Subject: Brunswick Steam Electric Plant, Unit Nos. 1 and 2  
Renewed Facility Operating License Nos. DPR-71 and DPR-62  
Docket Nos. 50-325 and 50-324  
Response to Request for Additional Information - Application to Revise Technical Specifications to Adopt TSTF-439, "Eliminate Second Completion Times Limiting Time From Discovery of Failure To Meet an LCO"

## **Response to Request for Additional Information**

### **Request for Additional Information**

Required Action B.1, One required Nuclear Service Water (NSW) pump inoperable.

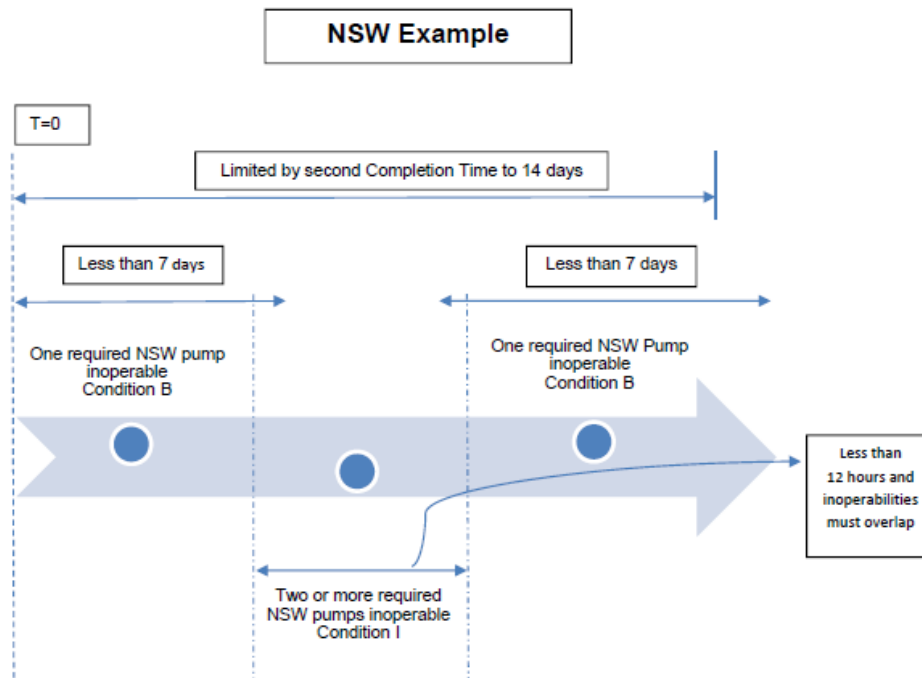
TSTF-439, Revision 2 provides a discussion of each of the specifications affected by the TSTF that justifies deleting the second CTs from the specification in NUREG-1433. The licensee's application does not provide a comparable discussion for the proposed variations. For the specifications listed in the BSEP variations, TS 3.7.2, TS 3.8.1, and TS 3.8.7, provide a discussion similar to that in TSTF-439 for each specification to justify proposed deletions of second CTs. In particular, this plant-specific justification should address the following:

- a. For TS 3.7.2, Required Actions B.1, C.2, and E.1, the identified more restrictive change;
- b. For TS 3.8.1, Required Actions B.3, C.3, and D.5, as applicable, unique TSs due to the BSEP's shared electrical distribution systems configuration and the reference to LCO 3.8.1 NOTES a or b;
- c. For TS 3.8.7, Required Actions A.1, B.1, C.4, and D.1, as applicable, unique TSs due to the BSEP's shared electrical distribution systems configuration.

Specification 3.7.2, SW System and Ultimate Heat Sink, has a 7-day Completion Time for one required NSW pump inoperable (Condition B) and a 12-hour Completion Time to be in Mode 3 for two or more required NSW pumps inoperable (Condition I). Condition B has a second Completion Time of 14 days from discovery of failure to meet the Limiting Condition for Operation (LCO).

The SW system is considered operable when it has two operable CSW pumps (unit dependent) and three site of the four NSW pumps (any combination of Unit 1 and Unit 2 NSW pumps). The loss of one NSW pump does not dictate entry into Required Action B.1. The loss of a second NSW pump (one of the three required) would dictate entry into Required Action B.1. This condition would not constitute a loss of safety function. The loss of a third site NSW pump (two of the three required) would dictate entry into Required Action I.1 and constitute a loss of safety function.

For the 14-day second Completion Time to be limiting, entry into and out of Condition B and Condition I must occur multiple times. This scenario would assume the loss of various NSW pumps multiple times, but with none of the overlapping inoperabilities lasting more than 12 hours (Condition I). This highly improbable scenario is further limited by the short Completion Times of Required Action I.1 (Be in Mode 3 within 12 hours) and Required Action I.2 (Be in Mode 4 within 36 hours).

Based on the above, the second Completion Time for Required Action B.1 is not required.

Required Action C.2, One required Conventional Service Water (CSW) pump inoperable.

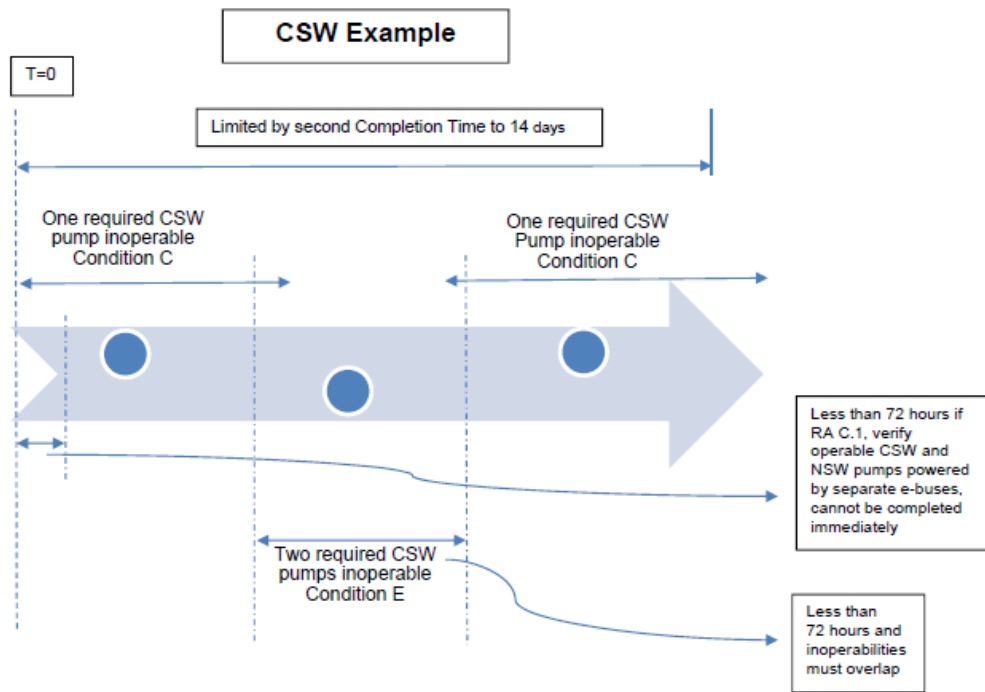
Specification 3.7.2, SW System and UHS, has a 7-day Completion Time for one required CSW pump inoperable (Condition C) and a 72-hour Completion Time for two required CSW pumps inoperable (Condition E). Condition C and E both have second Completion Times of 14 days from discovery of failure to meet the LCO.

The SW system is considered operable when it has two operable CSW pumps (unit dependent) and three site NSW pumps (any combination of Unit 1 and Unit 2 NSW pumps). The loss of one of the three CSW pumps on a unit does not dictate entry into Condition C. The loss of a second CSW pump (one of the two required) would dictate entry into Condition C. With one required CSW pump inoperable, the inoperable pump must be restored to operable status within 7 days. With the unit in this condition, the operable CSW pump and NSW pumps are adequate to perform the heat removal function. The 7-day Completion Time is based on the availability of two unit-specific SW pumps (an operable CSW pump and an operable NSW pump), each powered from separate 4.16 kV emergency buses, to support the unit's service water loads. The 7-day Completion Time is based on the remaining SW heat removal capability, a reasonable time for repairs, and the low probability of an event occurring during this time period requiring the SW System.

For the 14-day second Completion Time to be limiting, entry into and out of Condition C and Condition E must occur multiple times. This scenario would assume the loss of various CSW pumps multiple times, but with none of the overlapping inoperabilities lasting more than 72 hours (Condition E). This highly improbable scenario is further limited by the short Completion Times of Required Action I.1 (Be in Mode 3 within 12 hours) and Required Action I.2 (Be in Mode 4 within 36 hours). Furthermore, Required Action C.1, verify the one operable CSW pump and one operable unit specific NSW pump are powered from separate emergency buses, must be completed immediately. If Required Action C.1 cannot be verified, then Condition D is entered which requires the restoration of the inoperable CSW pump to be completed within 72 hours.

Based on the above, the second Completion Times for Required Action C.2 and E.1 are not required.
